Project	<b>IEEE 802.16 Broadband Wireless Access Working Group</b> < <a href="http://ieee802.org/16">http://ieee802.org/16</a> >
Title	<b>Corrections on Open loop power control for uplink</b>
Date Submitted	<b>2004-11-12</b>
Source(s)	Jaehee Cho, Seungjoo Maeng, Jaeho Jeon, <a href="mailto:jaehee1.cho@samsung.com">jaehee1.cho@samsung.com</a> Soonyoung Yoon, Jeong-Heon Kim, Jaehyok Lee, Myungkwang Byun, Inseok Hwang, Panyuh Joo, Jiho Jang, Sanghoon Sung, Hoon Huh, janghoon yang, ByoungHa Yi Samsung Electronics Co. Ltd.
Re:	Recirculation of P802.16 REVe/D5
Abstract	The current description of open loop power control has some errors. This contribution presents corrections for them. <a href="#">The contribution is revised reflecting comment #561, 563</a>
Purpose	Adoption of suggested changes into P802.16e/D6
Notice	This document has been prepared to assist IEEE 802.16. It is offered as a basis for discussion and is not binding on the contributing individual(s) or organization(s). The material in this document is subject to change in form and content after further study. The contributor(s) reserve(s) the right to add, amend or withdraw material contained herein.

## Suggested text change

Figure 20c - Bandwidth request and UL Tx power report header format

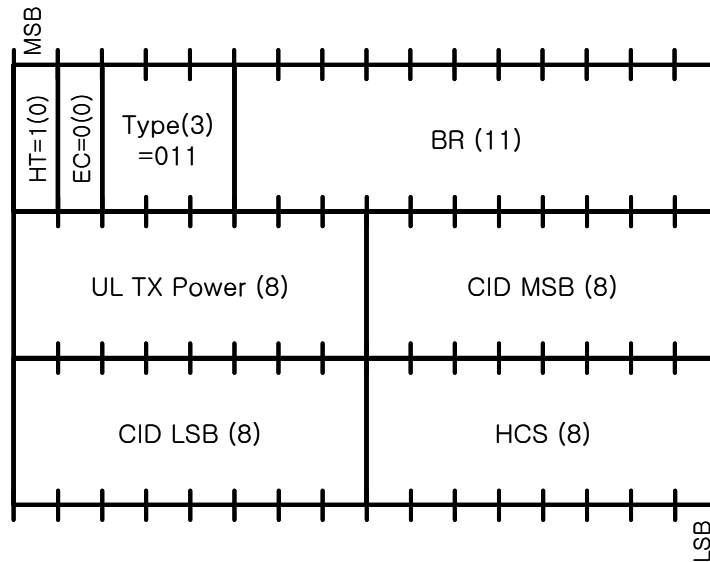
[Change the text as follows in 6.3.2.1.5]

The Bandwidth Request and UL Tx power report PDU shall consist of bandwidth request and UL Tx power report header alone and shall not contain a payload. The bandwidth request and UL Tx power report header is illustrated in Figure 20c.

The ~~the~~ bandwidth request and UL Tx power report header shall have the following properties:

- a) The length of the header shall always be 6 bytes.
- b) The EC field shall be set to 0, indicating no encryption.
- c) The CID shall indicate the SS basic CID.
- d) The TYPE field should be “011”.
